WESTERBEKE

MARINE ENGINE PRODUCTS

SERVICE BULLETIN 92

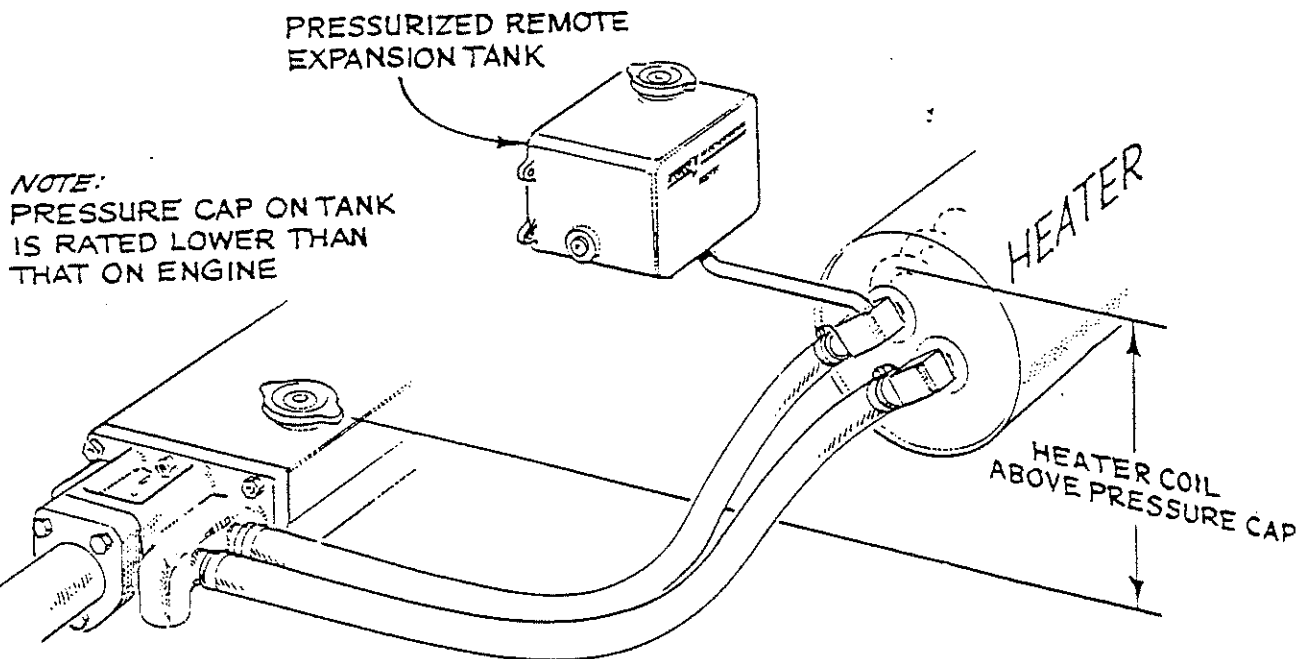
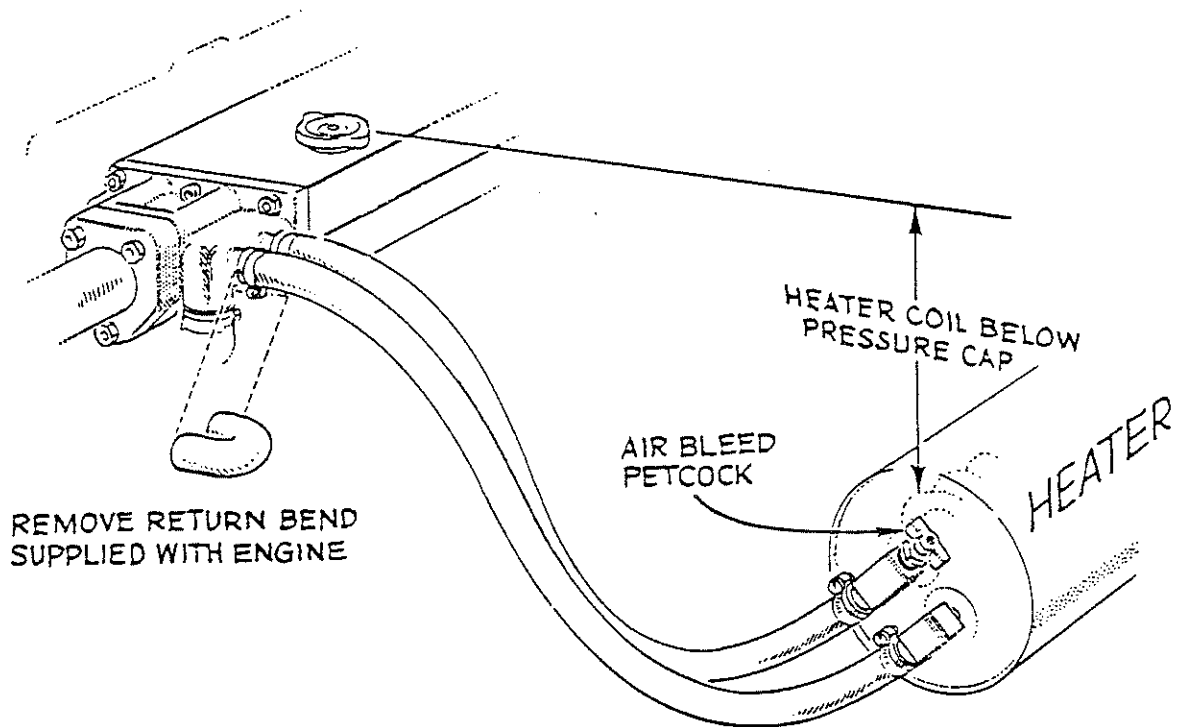
Principle: There are two 7/8" hose connections at the end of the manifold which provide a parallel flow of engine cooling water to and from the heater. These connections are part of the FLOWCONTROLLER which assures a flow of hot water through the heater at all times and yet precludes excessive restriction of engine cooling water flow caused by the heater - all simply and automatically.

Installation: Remove the returnbend which normally connects the 7/8" hose spuds on engines as shipped from the factory. Connect these spuds to the heater with 7/8" ID wire inserted hose. The spud marked "out" indicates the flow from the engine and the spud marked "in" indicates the flow returning to the engine.

Hoses should rise continuously from their low point at the heater and to the engine so that trapped air will rise naturally from the heater to the engine. If trapped air can rise to the heater, then an air bleed petcock must be installed at the higher fitting at the heater for bleeding the air while filling the system. Avoid loops in hose runs which will trap air.

If any portion of the engine cooling water circuit to or from the heater rises above the engine's own pressure cap, then the pressurized remote expansion tank must be installed in the circuit to be the highest point. The tank kit Part Number is 24177. Install the remote expansion tank in a convenient location such as a sail locker for ease of checking fresh water coolant level.

The cap on the engine mounted expansion tank/manifold should not be opened once the system is installed and filled.

The hose connection from the heater to the remote expansion tank should be routed and supported so as to rise continuously from the heater to the tank enabling any air in the system to rise.

ILLUSTRATION

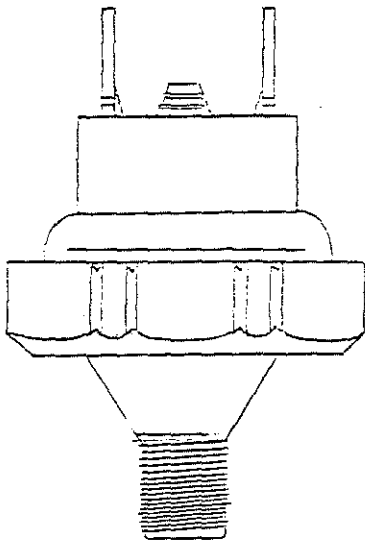
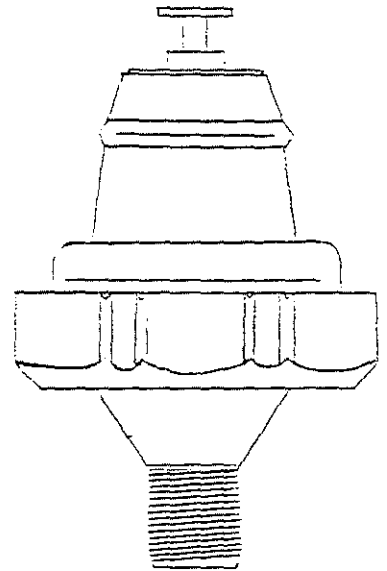
When removing and installing oil pressure switches of the type illustrated below, care should be taken to use the correct type socket specifically designed to correctly fit the metal circumference of these switches.

The correct socket can be acquired through well-known tool manufacturers such as Snap-On, New Britain, Cromwell, Proto and others. The use of channel lock pliers, vise-grips or pipe wrenches, is not advised, in that they may cause damage to the seal between the metal body and the plastic center insert, resulting in a leak and/or switch failure.

Minimum Travel (inner hole used)

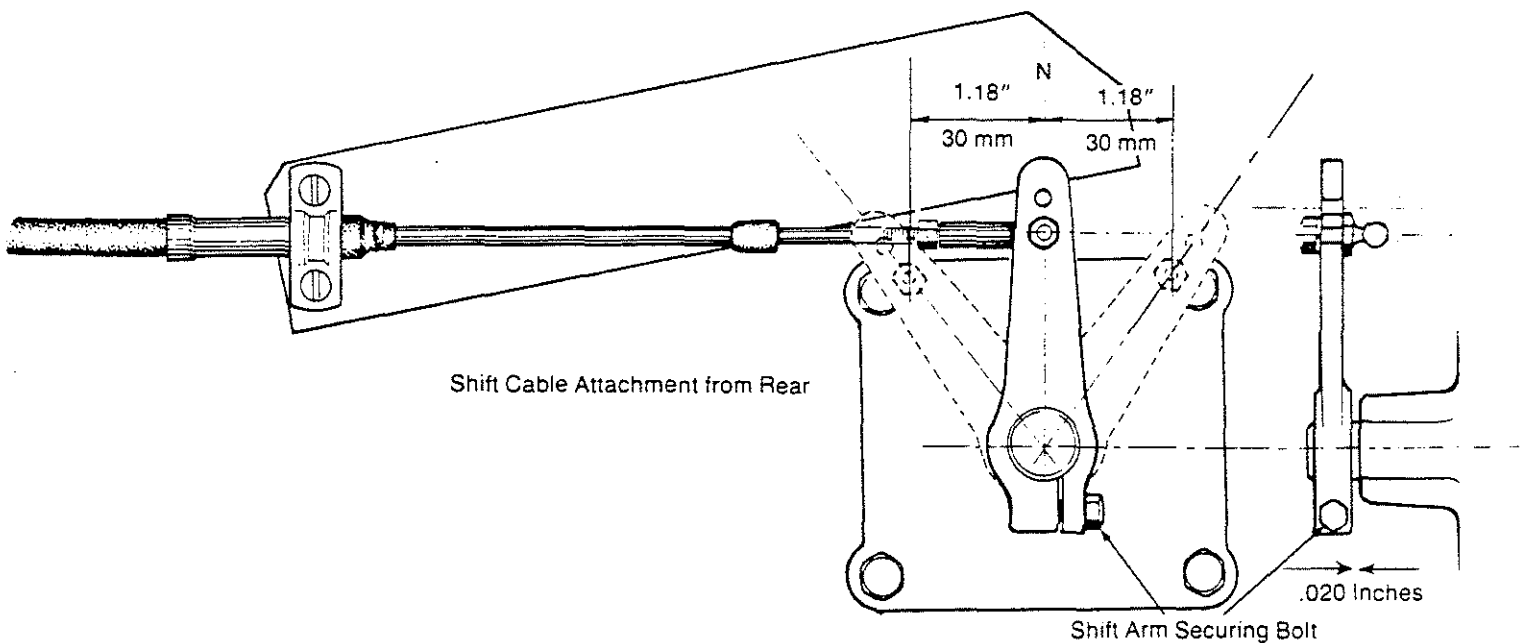
The control cable, when attached to the transmission shift arm ball joint connector, should be attached so as to be at a 90° angle with the lever and transmission in the neutral position (Ref. Illustration).

The transmission shift arm can be rotated on the transmission side cover shifting shaft by loosening the securing bolt (13mm) and rotating the shift arm to produce the 90° angle between the arm and the shift cable when the transmission is in neutral. Insure that there is at least .020 inch clearance between the shift arm and the shift cover before retightening the securing bolt.

The shift cable and pedestal control must allow the transmission shift arm to move from the neutral position into the forward or reverse engagement a MINIMUM of 1.37 inches (35mm) when the outermost ball joint attachment hole is used on the shift arm, or 1.18 inches (30mm) when the inner is used. Use of the inner attachment hole is preferred (Ref. Illustration).

Failure to properly adjust the shift arm and cable to produce the MINIMUM shift arm travel required for clutch engagement will result in clutch slippage and eventual failure.

Adjusting the shift arm and shift cable to produce shift lever movement greater than the minimum is recommended.

Movement at the shift arm preferably should be 1.5 to 2 inches of arm movement into the forward and reverse position. Cockpit controls must be of a design that will allow for this desired cable travel.

LATE MODEL TACHOMETER

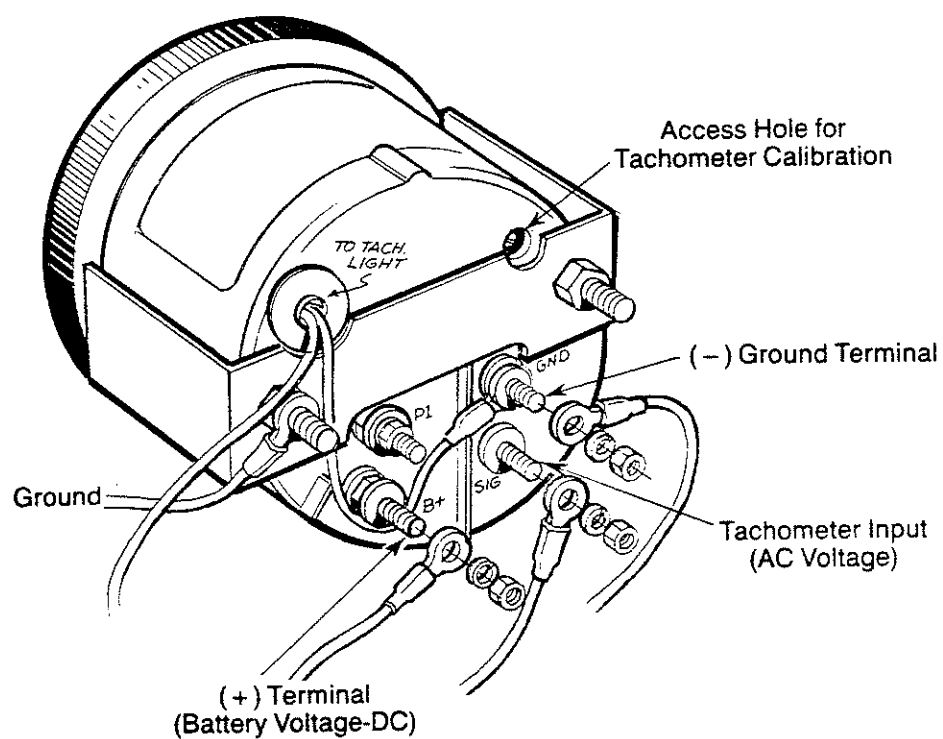
Replaces Earlier Model as Shown on Page 2 of this Bulletin

Alternator Mounting Kit #256891 Components

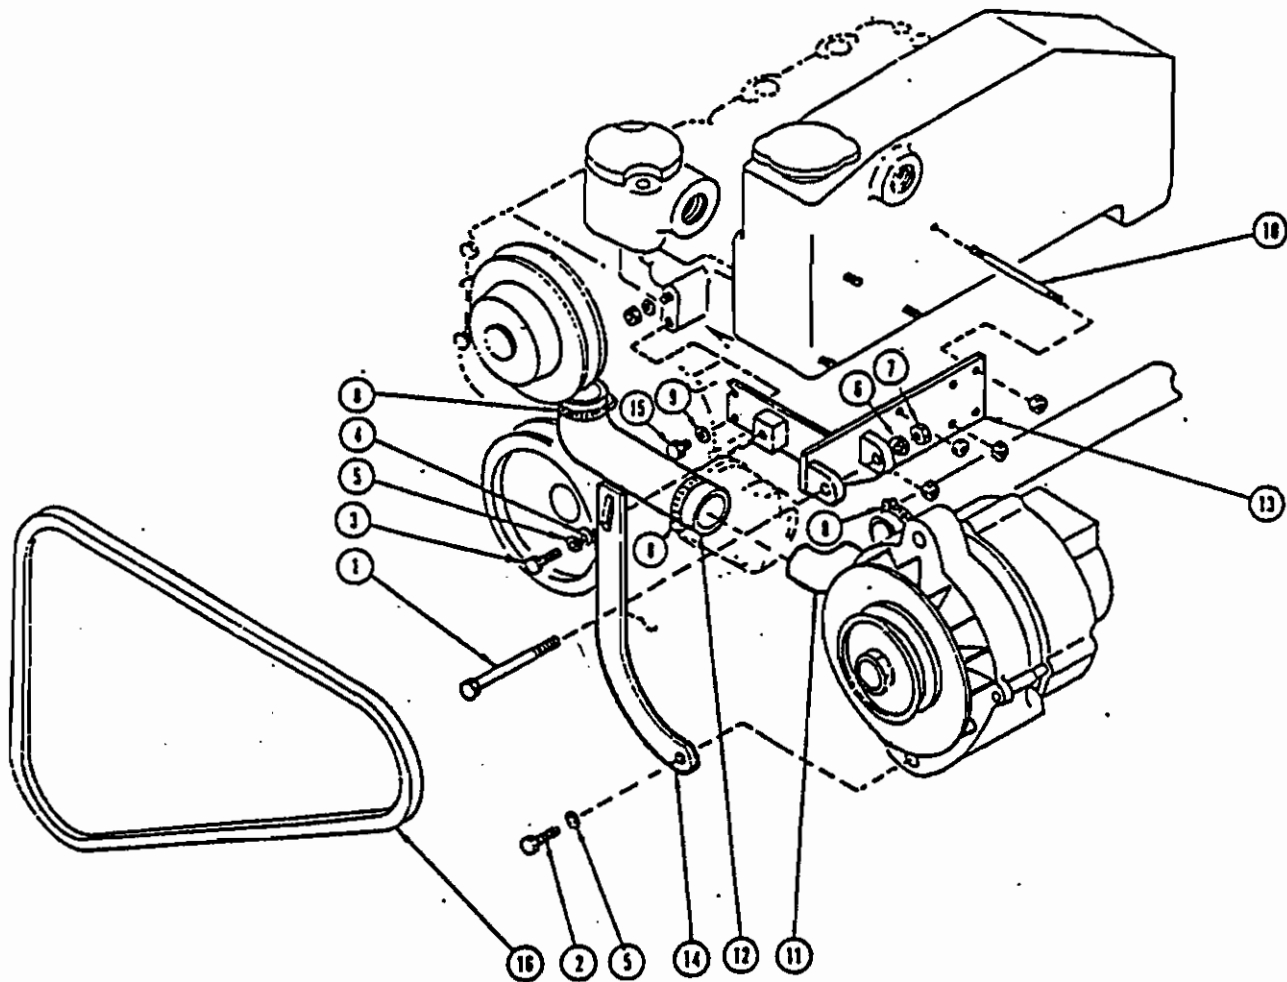
Westerbeke Corporation has become aware that some early model Universal M18, M25 and M25XP marine engines having the DC charging alternator mounted directly to the front gear case cover have experienced failure of the gear case cover at this mounting point.

Owners of these early Universal models are encouraged to inspect their units and if they find the DC charging alternator mounted directly to the front gear case cover that they purchase a conversion kit PN# 256891 that will allow for the mounting of the alternator on a bracket that is attached to the engine's exhaust manifold as later model engines were configured to. The illustration with this bulletin lists the kit components and shows their location on the engine.

Contact your local area Westerbeke/Universal dealer to order the alternator mount conversion kit #256891 and front gear case cover parts as needed.

Heat Exchanger Group - New Style

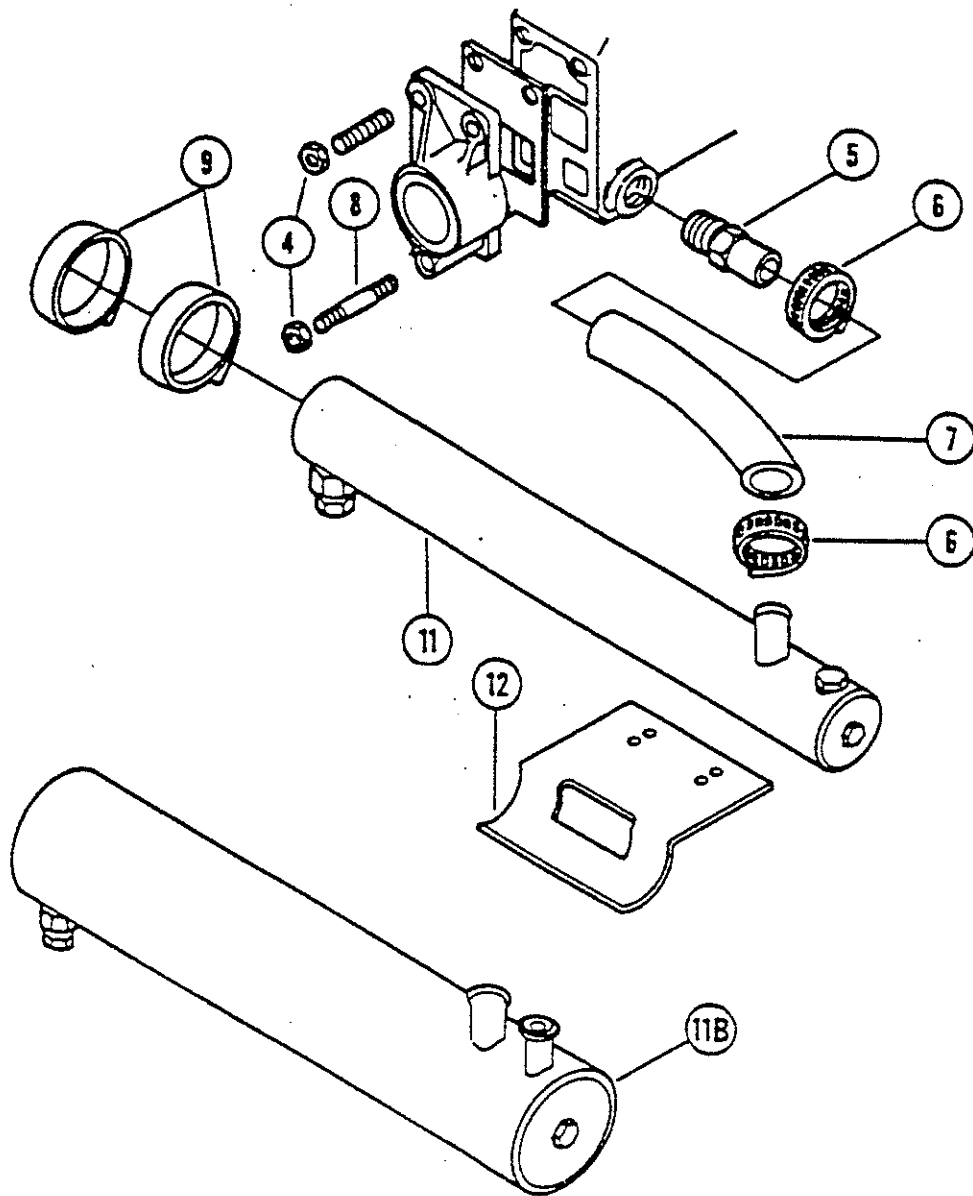
If these areas 1-6 have been inspected and any faults that are found are corrected and overheating still occurs, it is recommended that the operator consider replacing the two inch diameter heat exchanger (P/N #299049) originally supplied with the engine with the three inch diameter heat exchanger Universal incorporated on later models (P/N #299835).

The illustration shows this larger heat exchanger, reference #11B. The contoured mounting bracket reference #12 will have to be reworked to fit the contour of the larger exchanger. This can easily be done by removing the bracket and using a piece of three inch iron pipe as a template to rework the bracket to the proper contour. Use two cushions #033487 between the exchanger body and the bracket along with heavy duty clamps (P/N #303070) when mounting the heat exchanger to the reworked bracket. The illustration helps show these components.

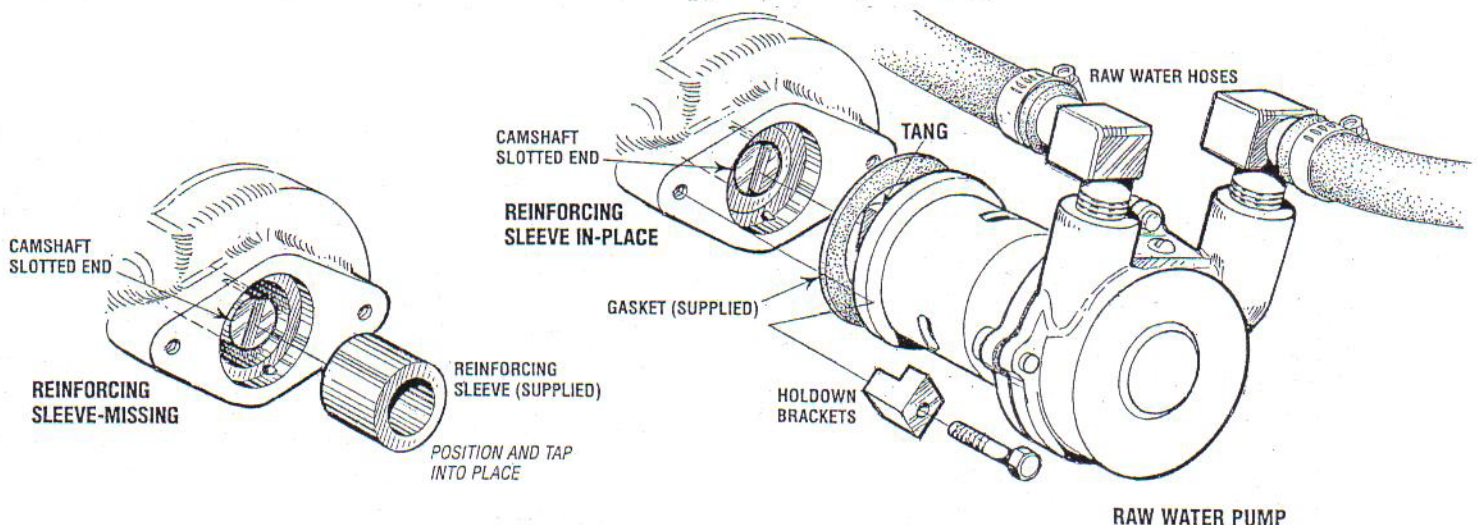
Owner/operators are advised to immediately remove the sea water pump off the front gear case of their engine and inspect the cam shaft sea water pump drive end to make sure it has this reinforcing sleeve. The illustrations show the cam shaft end with and without the reinforcing sleeve.

The reinforcing sleeve is easily installed as it is just a slight force fit fully over the sea water pump drive end of the cam shaft. Position the reinforcing sleeve squarely onto the end of the cam shaft and gently tap/push it fully onto the shaft end so it is flush with the end of the shaft.

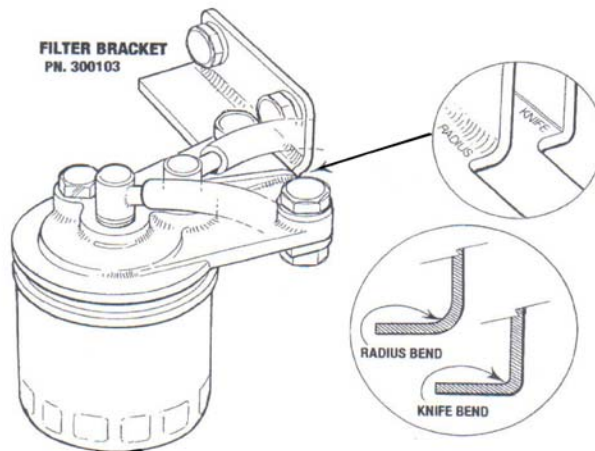
DETAIL: FRACTURES HAVE BEEN REPORTED FROM THE FIELD IN THE AREA OF THE 90-DEGREE BEND

IN THE #300103 BRACKET. INSPECTION OF BRACKETS RETURNED FROM THE FIELD HAS SHOWN THAT THE 90- DEGREE BEND WAS INCORRECTLY PERFORMED USING A KNIFE-EDGE BENDER RATHER THAN A RADIUS BENDER.

THIS KNIFE EDGE BENDING PROCESS PLACES A NOTICEABLE CREASE ALONG THE BEND WHICH CAN STRESS THIS AREA OF THE METAL CREATING THE POSSIBILITY OF A FRACTURE TAKING PLACE ALONG THIS CREASE.

THE ILLUSTRATION BELOW SHOULD HELP TO SHOW THE DIFFERENCES IN THE 90 DEGREE BEND.

THE ABOVE SUBJECT MODELS USING THIS BRACKET MANUFACTURED PRIOR TO SEPTEMBER 2004 (E409) ARE SUSPECT. VISUALLY INSPECT THE BRACKET AND IF A CREASE IS VISIBLE ALONG THE BEND AREA. CONTACT WESTERBEKE CORPORATION AT 508-823-7677. PROVIDE THE ENGINE MODEL AND SERIAL NUMBER AND A SHIPPING ADDRESS AND A REPLACEMENT BRACKET WILL BE SENT AT NO CHARGE.

CYLINDER HEAD GROUP

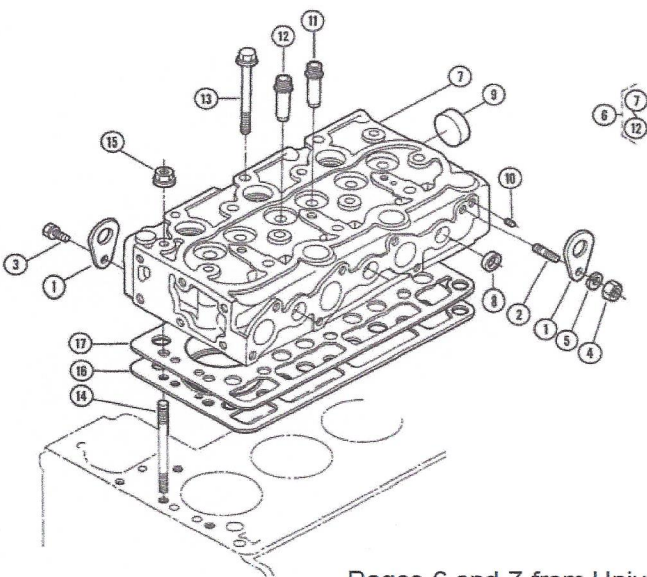
DETAIL: Confusion regarding when to use the cylinder head shim, reference 17 illustrated below, included in complete or upper gasket sets for the M25 and M25XP products has prompted the following explanation of when use of the shim is required.

Upon assembly of the engine by the manufacturer the cylinder head to piston top height clearance is measured to determine if a shim is needed. This results in inconsistency from one engine to the next. When replacing the cylinder head gasket on the subject models pay attention to whether a shim was originally used. Be sure to use the new shim if one originally existed in order to avoid the possibility of interference issues.

In the event you did not disassemble the engine and you do not know if a shim was used originally we recommend both the gasket and shim be installed to avoid problems. Installing a shim in either case is acceptable and preferred.
